RE: Project No. 1599147
British Columbia Utilities Commission (BCUC or Commission)
British Columbia Hydro and Power Authority (BC Hydro)
2020 Street Lighting Rate Application (the Application)

BC Hydro writes in compliance with Commission Order No. G-43-21 to provide its responses to Round 2 information requests as follows:

British Columbia Agriculture Council and British Columbia Cattlemen's Association Information Request No. 2.13.1 Dated: March 11, 2021 British Columbia Hydro & Power Authority Response issued April 1, 2021	Page 1 of 2
British Columbia Hydro & Power Authority Street Lighting Rate Application	Exhibit: B-7

Figure 1: MV & HPS RS 1755 Outdoor Lights

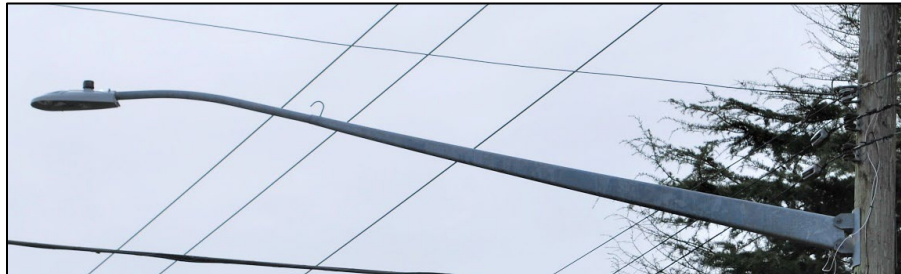
British Columbia Agriculture Council and British Columbia Cattlemen's Association Information Request No. 2.13.4 Dated: March 11, 2021 British Columbia Hydro & Power Authority Response issued April 1, 2021	Page 1 of 2
British Columbia Hydro & Power Authority Street Lighting Rate Application	Exhibit: B-7

The designs of the mercury vapour and high pressure sodium lights and brackets (arms) used for RS 1755 are not compatible with today's HPS or LED street light luminaires. This is illustrated in Figure 1 and Figure 2 below. As such, the

replacement of RS 1755 lights would result in the replacement of both the luminaire and the bracket.
